GE Hitachi Nuclear Energy

MFN 08-882

Subject: Response to NRC Request for Additional Information Letter No. 165 Related to Licensing Topical Report NEDC-33373P, Revision 0, "Dynamic, Load Drop and Thermal-Hydraulic Analysis for ESBWR Fuel Racks," November 2007 RAI Numbers 9.1-51 through 9.1-76

**Response to NRC Request for
Additional Information Letter No. 165 Related to
Licensing Topical Report NEDC-33373P, Revision 0,
“Dynamic Load-Drop and Thermal-Hydraulic Analysis for
ESBWR Fuel Racks”**

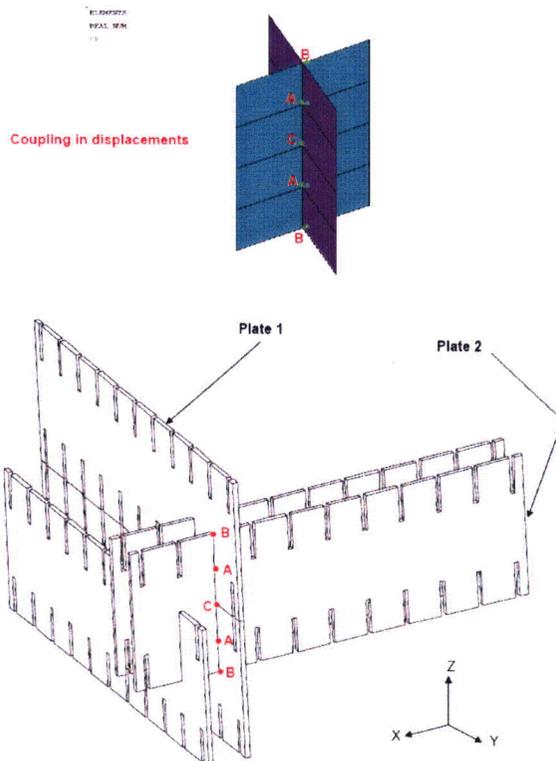
LTR NEDC-33373P, Section 1.4.5 provides the finite element model for FSR analysis. The description in the third bullet for the borated SS plates is not clear how in the finite element model the [[]] connections for the borated plated are modeled in terms of displacements and rotations at connected nodes. The staff requests that GEH provide a clearer description of the [[]] connections, preferably using figures.

The figure below provides a pictorial presentation of how the borated stainless steel plates interlock to form the internal grid of the spent fuel storage racks in both the Buffer Pool and Spent Fuel Pool. This figure also shows how coincident nodes (one per BSS plate) at each point (A, B, or C) are coupled and modeled in the FEM in terms of displacement, where:

“U” defines displacement

“1 or 2” indicates plate number, as noted

“x, y, z” indicates direction, as noted

There are two (2) nodes on each intersection point: one node for Plate 1 and one node for Plate 2

In Points A : $U_{1x} = U_{2x}$; $U_{1y} = U_{2y}$; $U_{1z} \neq U_{2z}$

In Points B : $U_{1x} = U_{2x}$; $U_{1y} \neq U_{2y}$; $U_{1z} \neq U_{2z}$

In Points C : $U_{1x} \neq U_{2x}$; $U_{1y} = U_{2y}$; $U_{1z} \neq U_{2z}$
